8 April 2025

PART 2 ENVIRONMENTAL AUTHORISATION AMENDMENT APPLICATION FOR THE PROPOSED BEAUFORT WEST SOLAR PV ENERGY FACILITY ON THE REMAINDER OF FARM OUDE VOLKS KRAAL NO. 164, FARM QUAGGAS FONTEIN NO. 166, PORTION 1 AND 3 OF FARM STEENROTSFOUNTAIN NO 168, AND PORTION 10 OF FARM WELTEVREDEN NO. 170, NEAR BEAUFORT WEST IN THE WESTERN CAPE PROVINCE: AQUATIC BIODIVERSITY SPECIALIST ASSESSMENT

Figure 1. Screening Tool mapping for Aquatic Biodiversity Sensitivity with the proposed amended PV footprint indicated by the orange polygons.

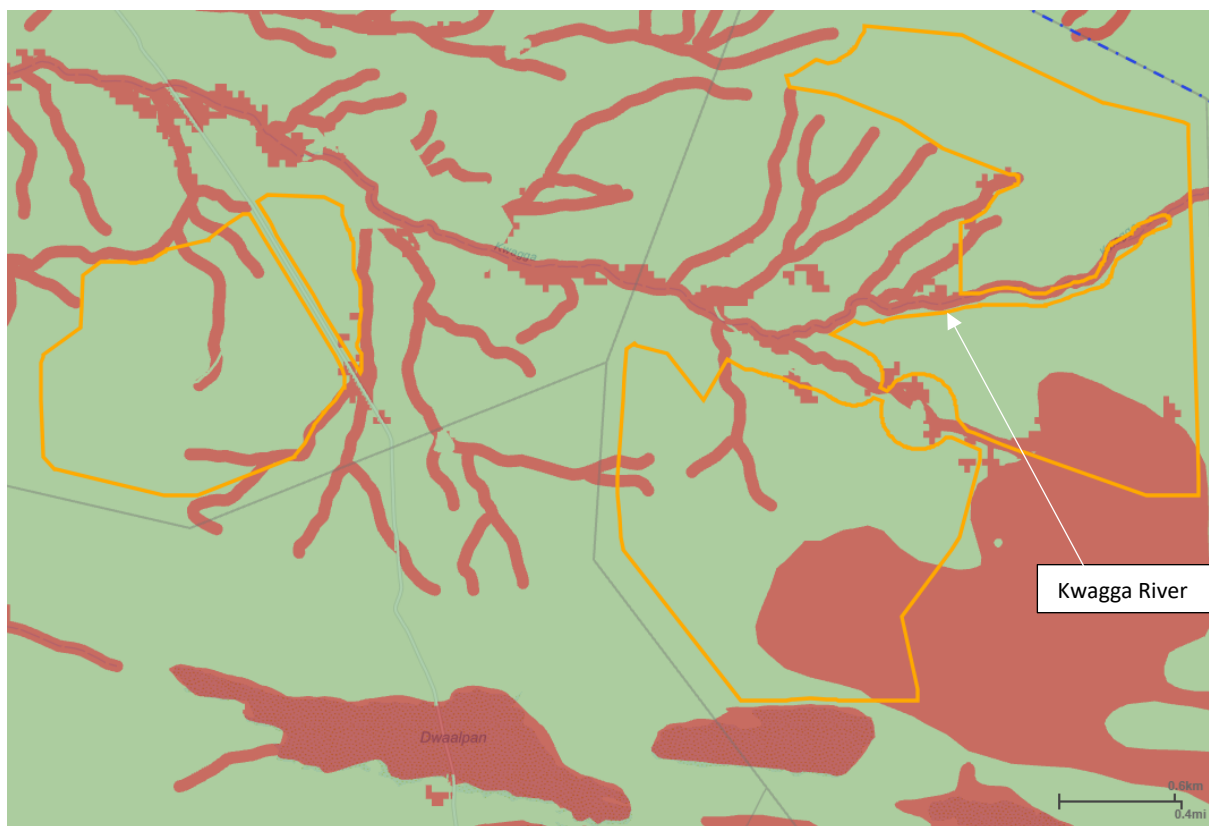
The Screening Tool (shown below with the preferred amended layout for the PV areas) has indicated that the wider area surrounding the site is mapped as being of low Aquatic Biodiversity Combined Sensitivity with the larger Kwagga River and the depression wetlands to the southeast being of very high sensitivity. The areas of high sensitivity are mostly linked to the depression wetlands in the southeast of the project area of influence that have been included in the National Wetland Map version 5 (NWM5), National Freshwater Ecosystem Priority Area (NFEPA) wetland mapping and in the Western Cape Biodiversity Spatial Plan (WCBSP) as aquatic Critical Biodiversity Areas (CBAs). Sections of the Kwagga River are mapped as aquatic CBAs and Ecological Support Areas. The approved PV footprints avoided all of the high-sensitivity areas however the amended PV footprint extends into some of the areas. These areas were specifically ground-truthed in the recent 24 February 2025 site visit.

Figure 2. Mapping of the 2023 WCBSP CBAs, NWM5 and the NFEPA Wetlands for the proposed project area of influence.

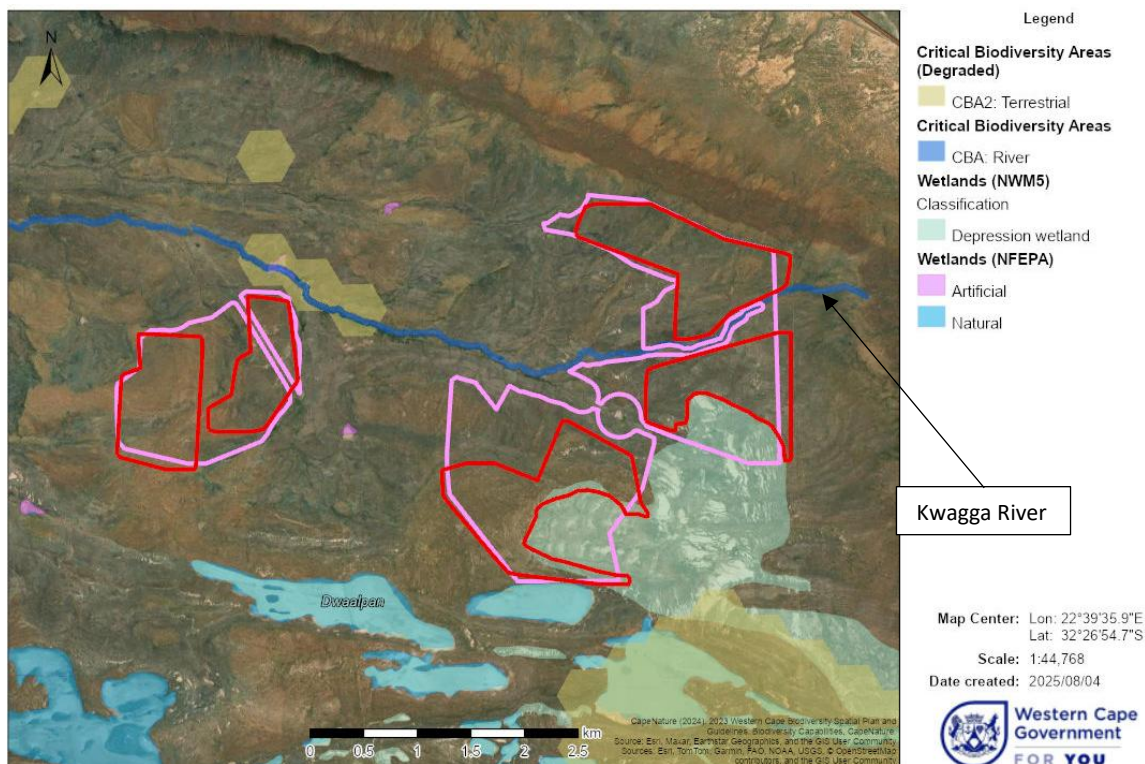
The aspects of concern with regards to the proposed amendment are the change to the footprint of the PV areas and the associated infrastructure areas that include the laydown area, O&M buildings, construction camp, Eskom switching station, BESS and IPP substation. The widening of access roads where they cross watercourses can easily be mitigated such that there would be no increase in impact. The areas where the PV modules and associated infrastructure have extended into the areas mapped as being of very high sensitivity in the southeast of the project area are within an area mapped as a depression wetland. This area in the ground-truthing was found to often be a higher-lying area with areas devoid of vegetation and was not associated with any wetland habitat. The other areas mapped as being of very high sensitivity related to smaller watercourses that are tributaries of the Kwagga River that have been mapped as aquatic ESA but ground-truthing determined them to comprise minor watercourses and drainage features of little aquatic ecosystem significance and providing little in terms of ecological services. The upper reaches of the larger Kwagga River and a 30m buffer that is mapped as an aquatic CBA are avoided by the proposed amended layout.

Figure 3. Google Earth image with the proposed amended layout for the project, shown together with the mapped aquatic features (top image) and the recommended buffer or setback areas (bottom image).

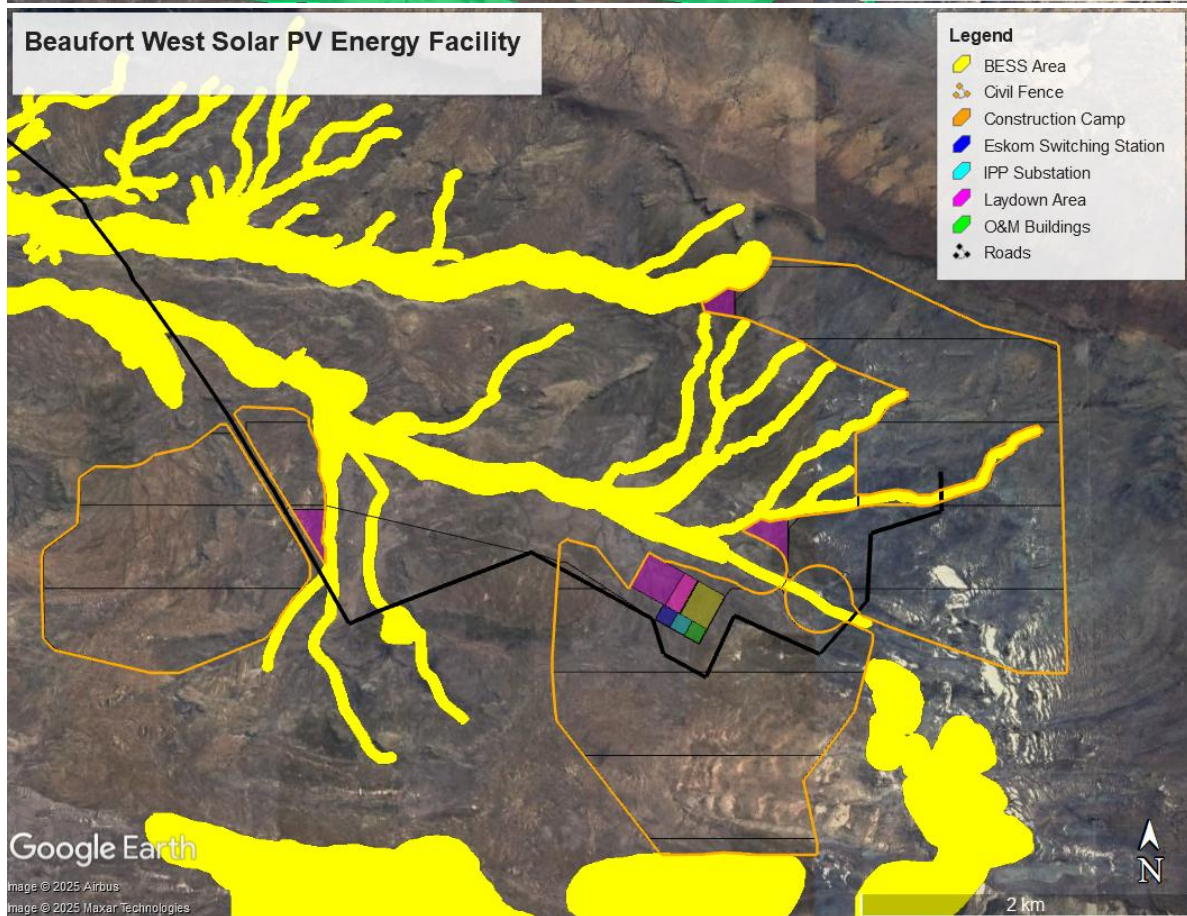
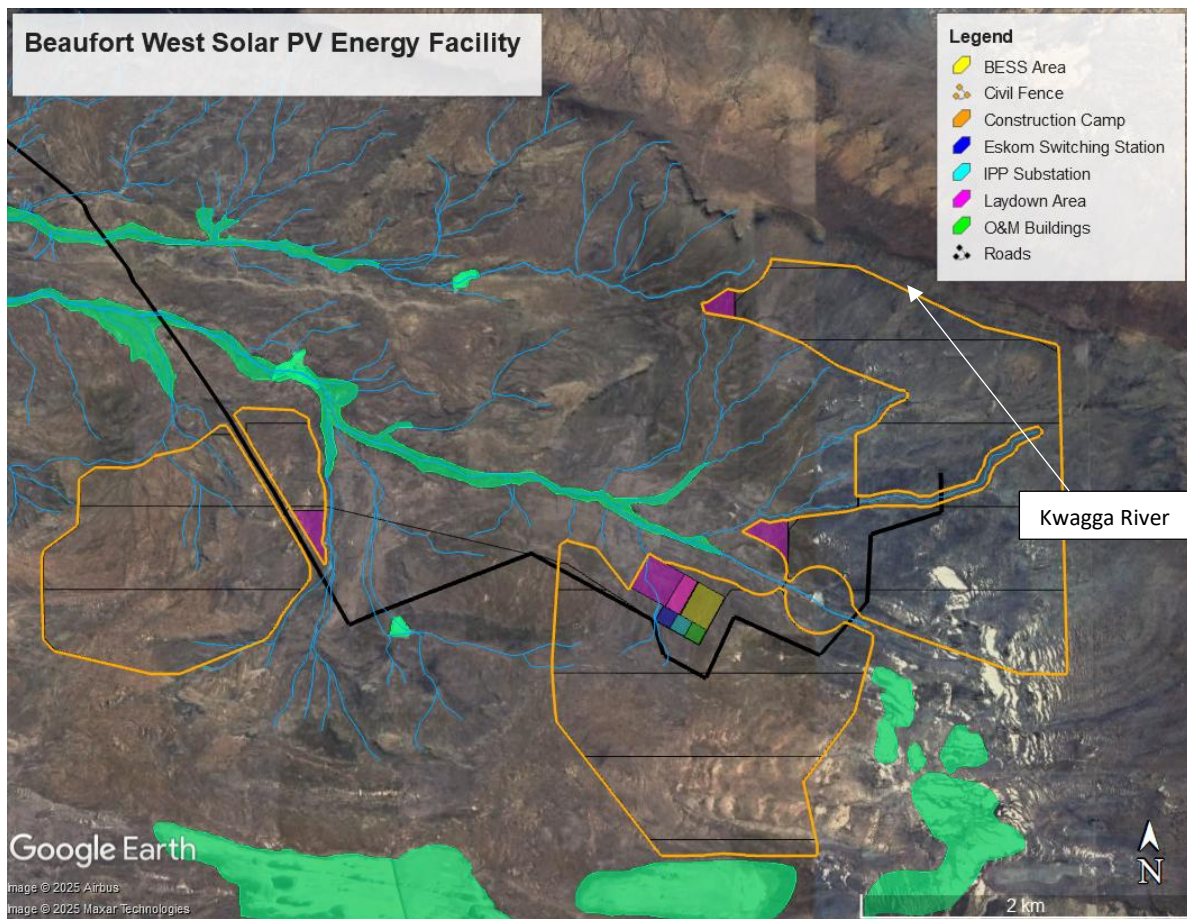
Figure 3 shows the proposed amended layout for the Beaufort West SEF, together with the mapped aquatic features as well as the recommended setback areas. I, Antonia Belcher who undertook the initial aquatic biodiversity assessment for the proposed project, confirm that the proposed amended layout does not alter the findings of the aquatic ecosystem impact assessment dated November 2022 i.e. **the proposed amended layout slightly increases the risk to the aquatic ecosystems as it is closer to the ground-truthed and mapped features, but does not result in any significant increase in level or change in the nature of impacts. The mitigation measures provided in the original aquatic ecosystem assessment report are deemed sufficient to manage the increase in risk and still maintain the ecosystems in their current ecological state, providing the same level of ecosystem goods and services.**

Figure 4. Google Earth image with the proposed amended layout alternatives for the project, shown together with the mapped aquatic features.

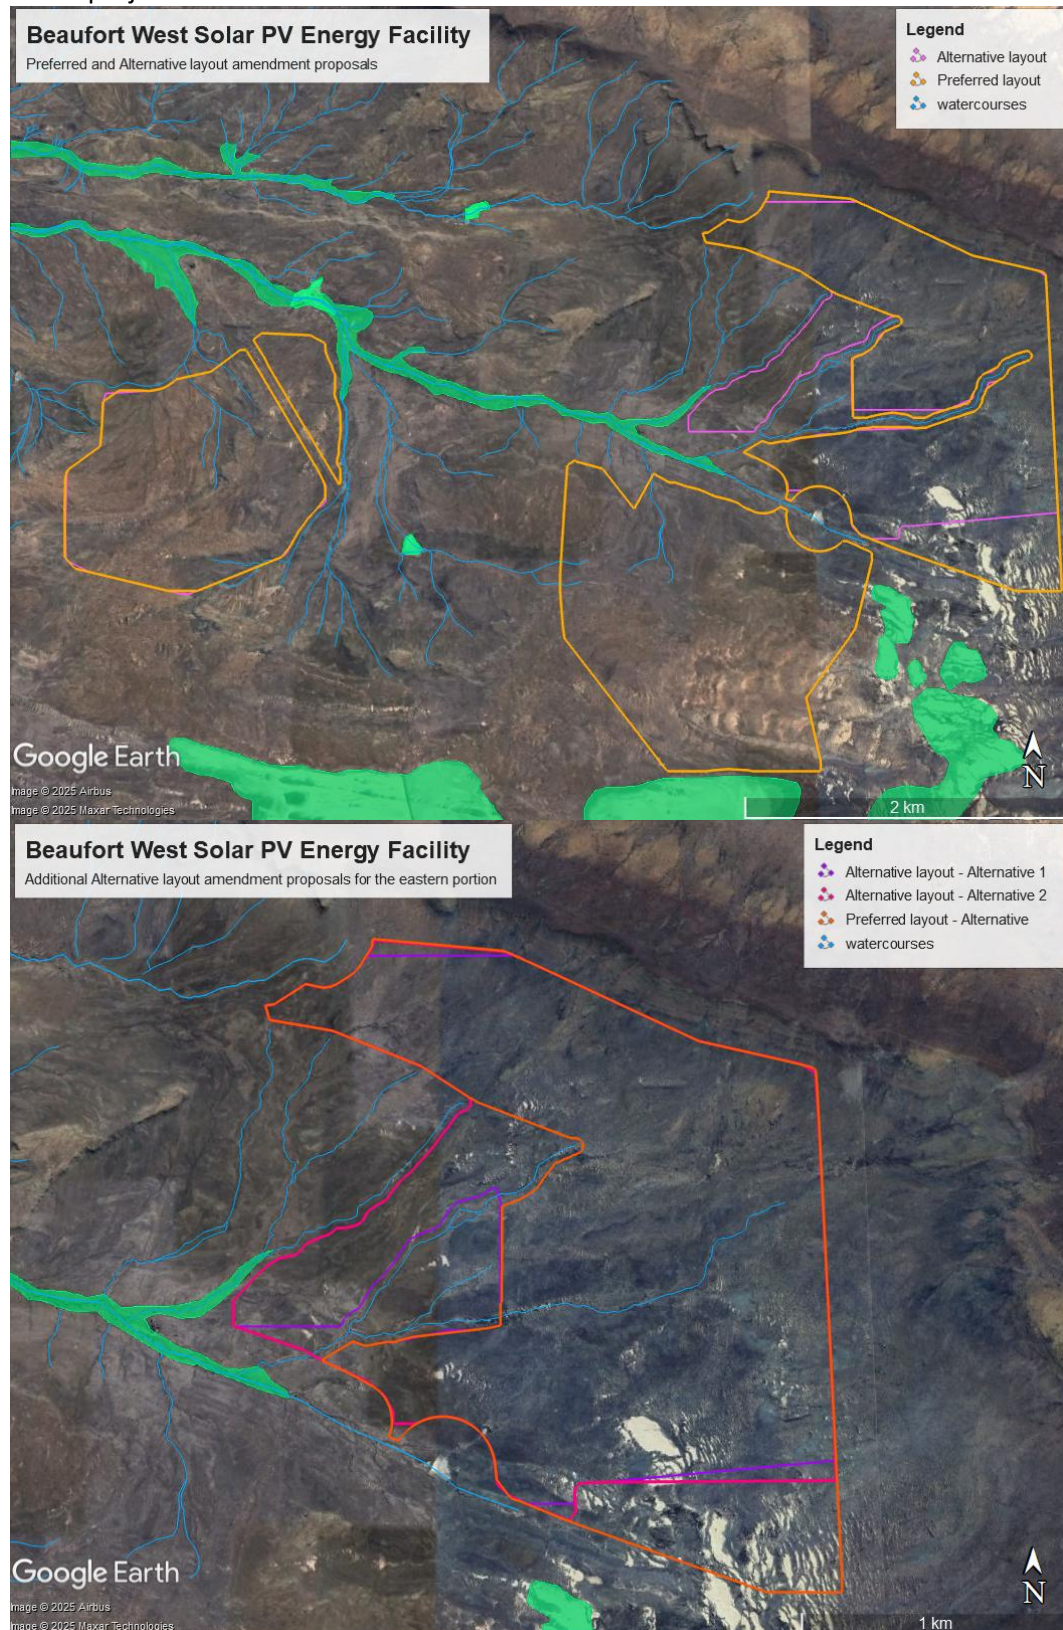
In terms of the proposed alternative layouts, the Preferred alternative is preferred to all of the other alternative layouts proposed that would result in the loss of the very upper reaches of the Kwagga River which is mapped as an aquatic CBA in the 2023 WCBSP. The figures below show a comparison of the preferred and alternative layouts as well as the additional alternatives for the eastern portion of the project.
